**PROPOSED TECHNICAL SPECIFICATIONS**

**Marked up Technical Specification Pages**

3/4 3-18  
3/4 3-19 (For information only)  
3/4 3-21  
3/4 3-26  
3/4 3-27 (For information only)  
3/4 3-33

9402080244 931228  
PDR ADDCK 05000250  
P PDR

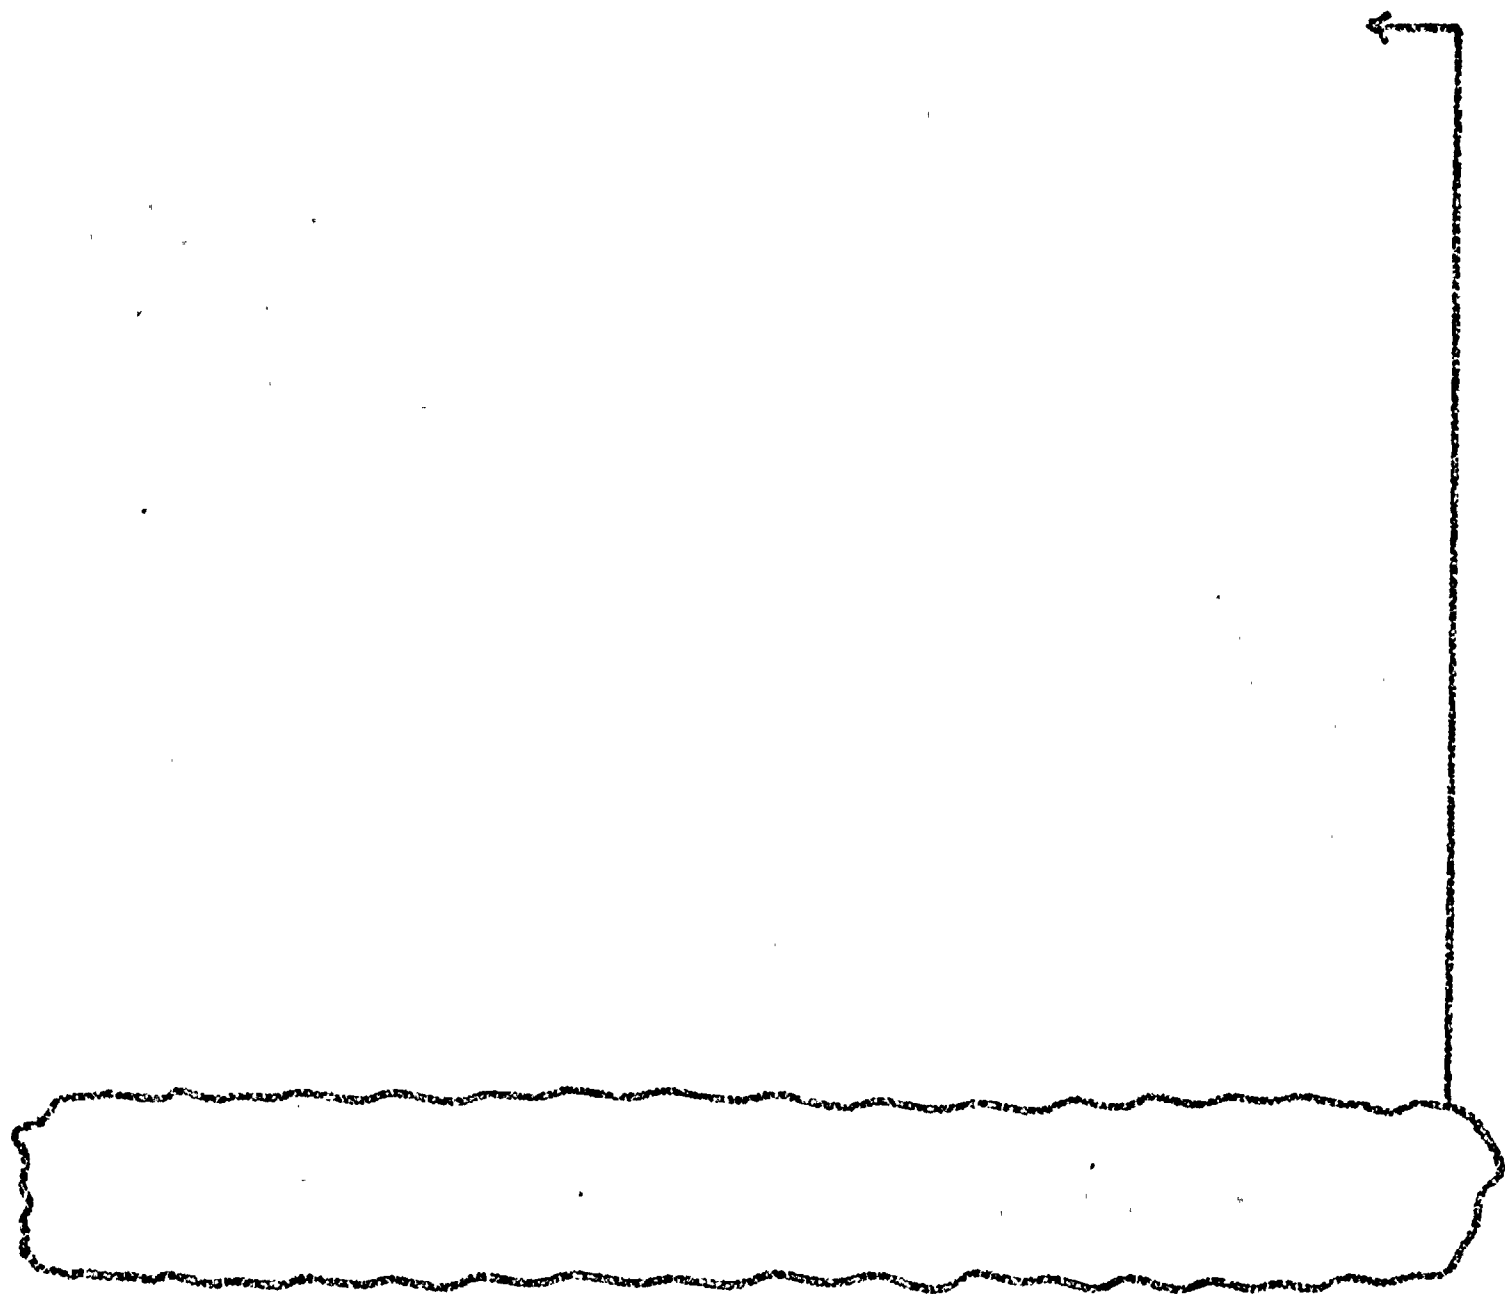
6. Auxiliary Feedwater###					
a. Automatic Actua- tion Logic and Actuation Relays	2	1	2	1, 2, 3	20
Stm. Gen. Water Level -- High - High #####	3/steam Generator	2/steam generator in any operating steam generator	2/steam generator in any operating steam generator	1, 2	15

#### Steam Generator overfill protection is not part of the Engineered Safety Features Actuation System (ESFAS), and is added to the Technical Specifications only in accordance with NRC Generic Letter 89-19.
